**Municipal Services Center, Council Chamber
3600 Tremont Road**

BZAP Meeting Date: February 4, 2026

Subject: 2490 Wickliffe Road (VAR-10-26) - To allow the construction of a new single-family residence that does not meet residential design standards. [Postponed from January 21, 2026 BZAP hearing.]

Subject: 1694 Essex Road (VAR-12-26) - To allow a two-story addition and garage which results in two variances: a 7.34 inch encroachment into the side yard longwall setback where an 11.34-inch setback is required, and projects into the rear yard profile. [Postponed from January 21, 2026 BZAP hearing.]

Elevations

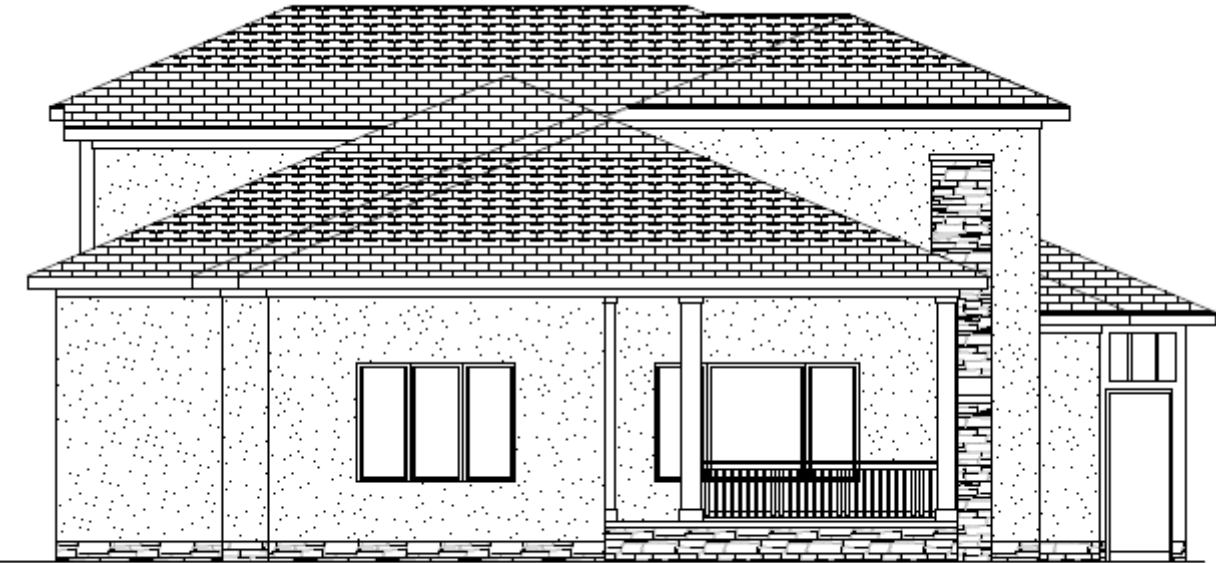
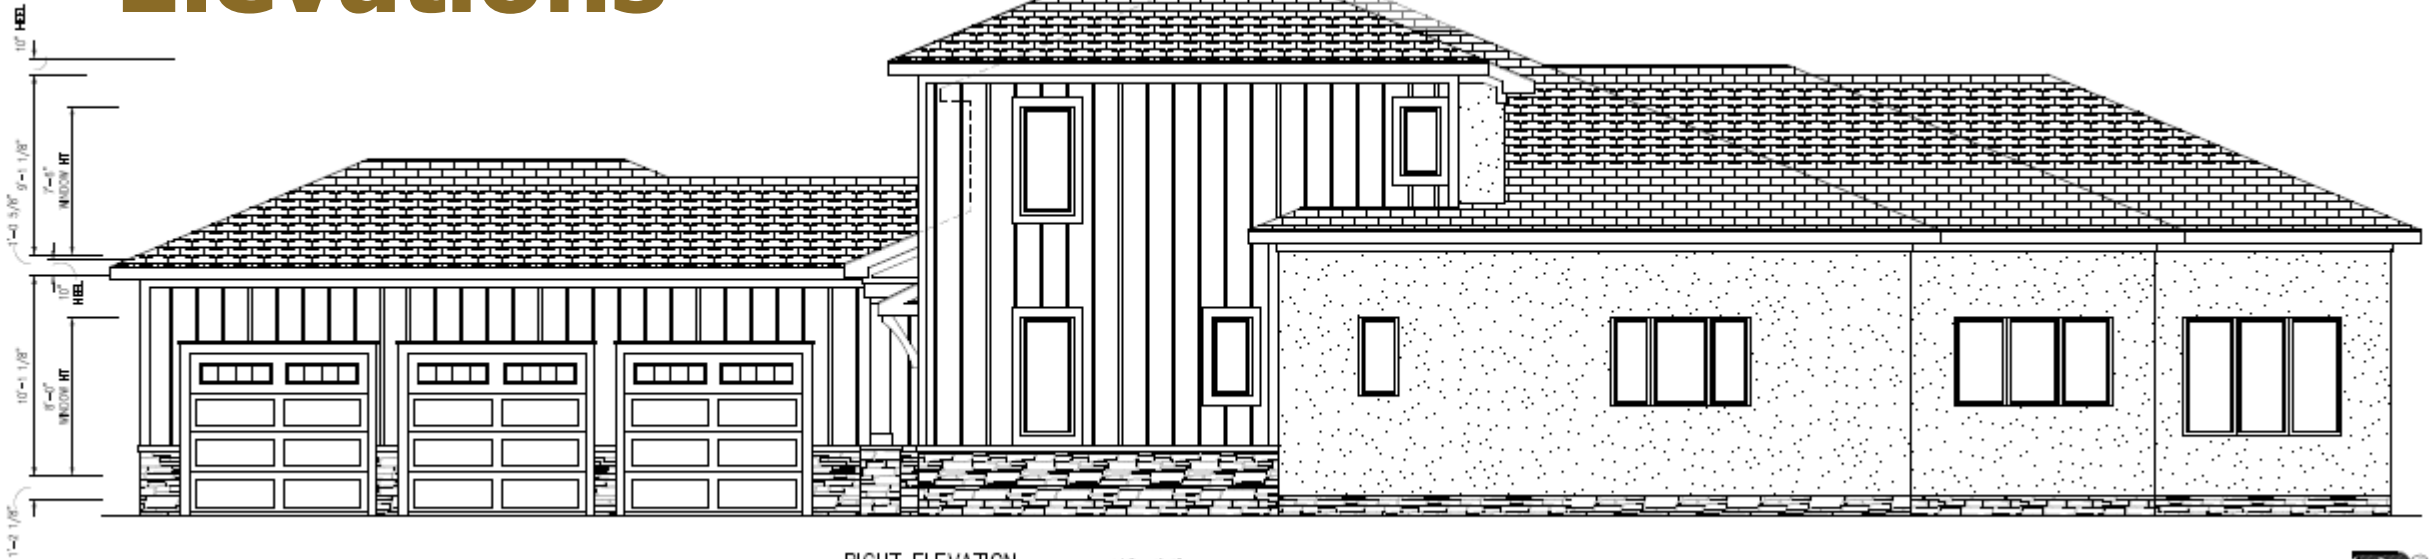
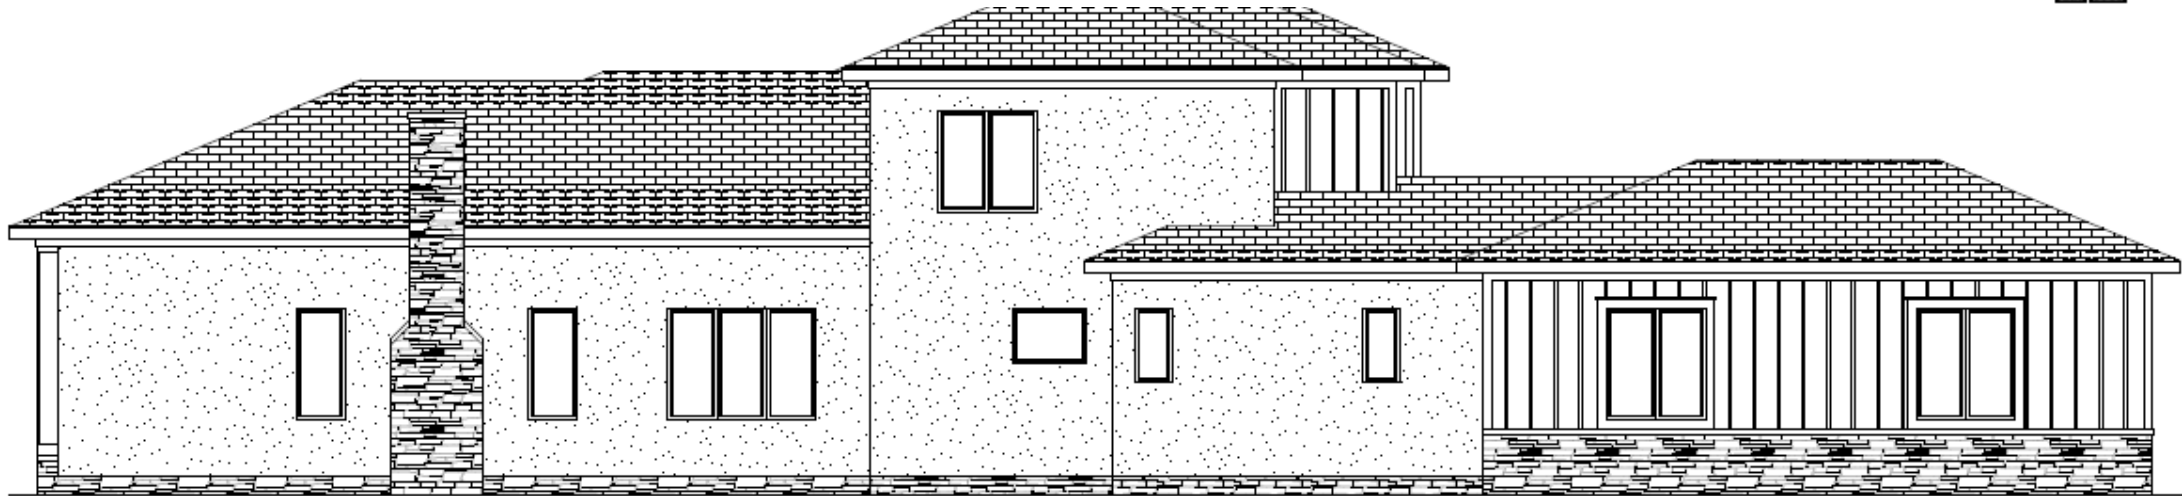
At the January 21, 2026 BZAP hearing, the Board postponed consideration of the proposed 1.5-story single-family residence, which required variances to the residential design standards. The Board appeared to be generally supportive of the proposed design, including the proposed exterior materials, but recommended several modifications:

1. Revise the front porch so that the roof is above the first floor level, similar to a previous design;
2. Examine the placement and types of windows used on all elevations so that they coordinate; and
3. Expand the proposed landscaping plan to the front yard.

The Board felt the front porch revision would help improve the massing and accessibility of the home, and agreed with Staff that the window package needed closer study. They were accepting of the proposed landscape plan, which helps mitigate the proposed depth of the home, but wanted to see it expanded to the front yard. They also felt the proposed exterior materials were prudent for the design and were used elsewhere on the street segment. There were limited concerns about its proposed depth and garage orientation.

[The City's third-party architect has approved the revised plan based on the Board's feedback from the recent hearing and continues to support the additional height (see original staff report). The proposed height is at the 28-foot height limit for the River Ridge. Based on the policy, a variance would not be needed if the home's depth were four feet shorter. The applicant has explored ways to eliminate this request, but has been unable to identify space to remove. A variance would also not be needed if the height of the home were reduced by 2'-6". This additional height was required by the third-party architect in order to get a steeper roof pitch to blend with the existing street segment.]

Revised Elevations

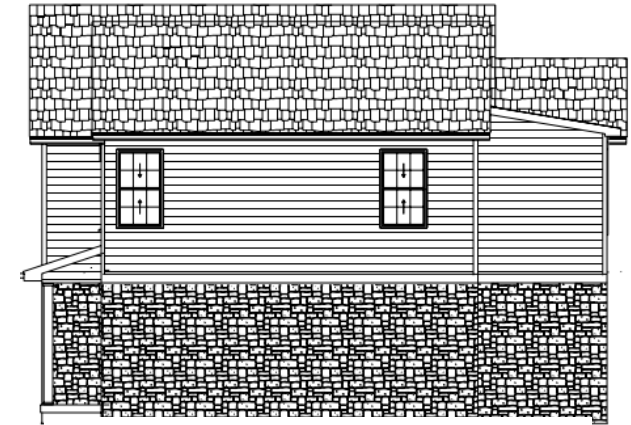
At the January 21, 2026 BZAP hearing, the Board postponed consideration of the proposed two-story addition and garage, which required three variances: a 7.34-inch encroachment into the side yard longwall setback where 11.34 inches is required, an encroachment into the rear yard profile, and the design not meeting the Residential Design Standards. While the Board was generally supportive of the proposed design and variances requested, several modifications were recommended:

1. Remove the small side porch and mandoor facing Harford Road and replace them with two windows;
2. Extend the existing porch facing Harford Road to provide weather protection across the new entryway and terminate it at the south corner of the proposed garage; and
3. Add steps along the walkway leading to the Harford Road entryway to address changes in site grade.

The Board indicated that these modifications would help reduce the perceived massing of the addition, better integrate it with the original residence, improve overall functionality, and limit the number of entrances to the home.

The applicant has made the requested changes and eliminated a variance, resulting in an improved design. To help soften the residence's depth and protect adjacent views from neighboring properties, Staff recommends a condition requiring additional landscaping along the north, east, and west property lines. Should the Board support this application, Staff would recommend that Finding #3 (minimum necessary) and #4 (essential character of the area) be considered, along with the following condition:

1. That a landscape plan is submitted with the Building Permit, which provides additional plantings along the north, east, and west property lines, subject to approval by the City Forester.

5 ELEVATION NORTH AT COURTYARD
1/8" = 1'-0"
REF: 1 / A101B

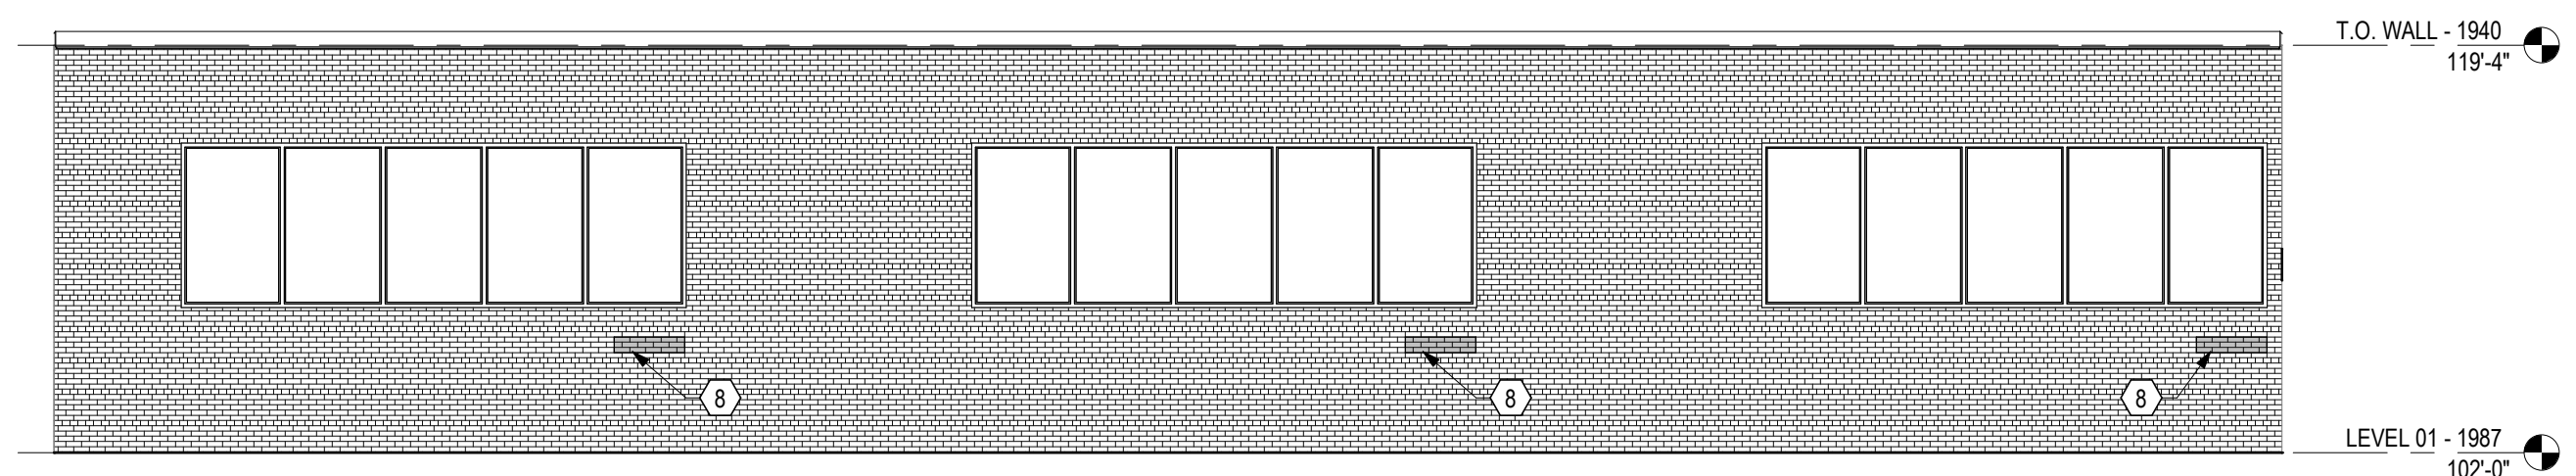
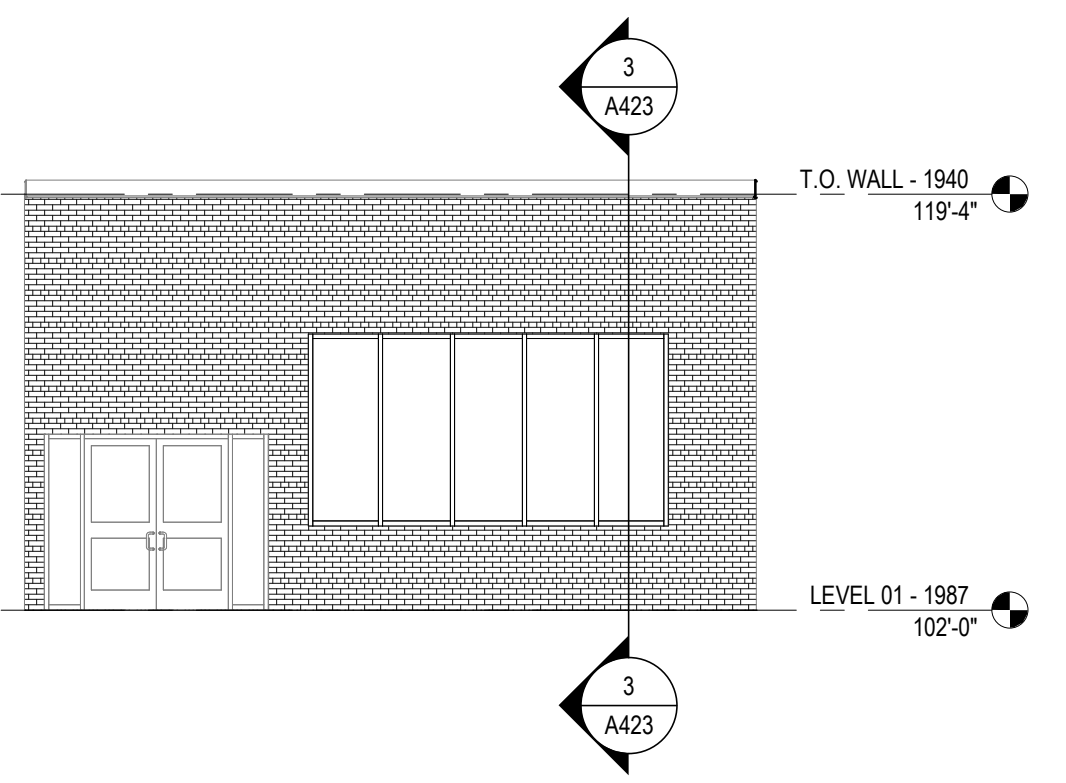
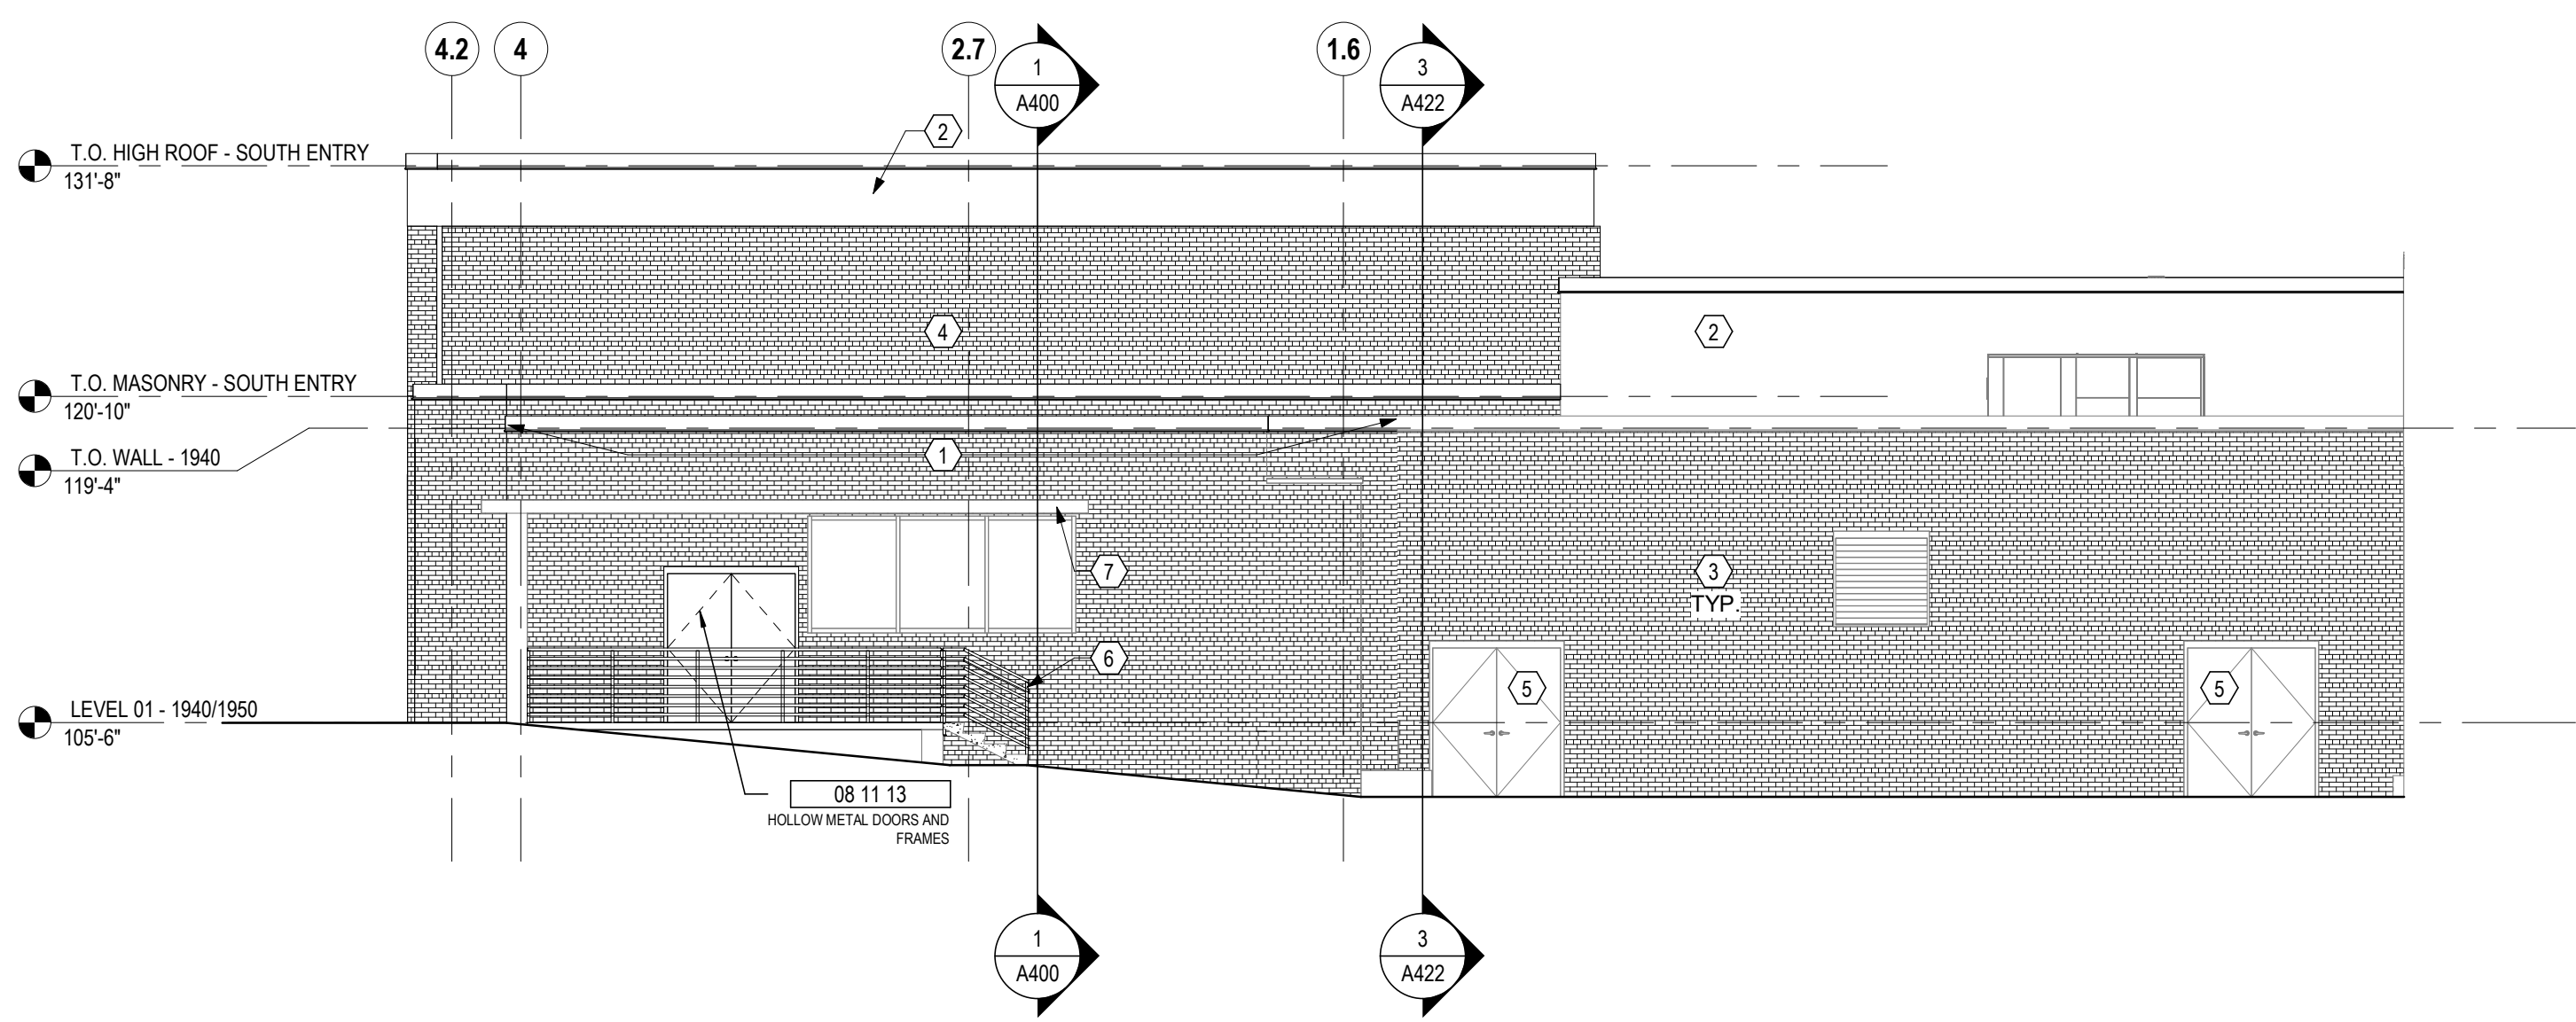
- Provide a detailed floor plan showing what is new or renovated;
- Examine window placement and entry cover at north and south courtyard elevations;
- Consider extending the spandrel glass above the Upper School entry in place of the brick band;
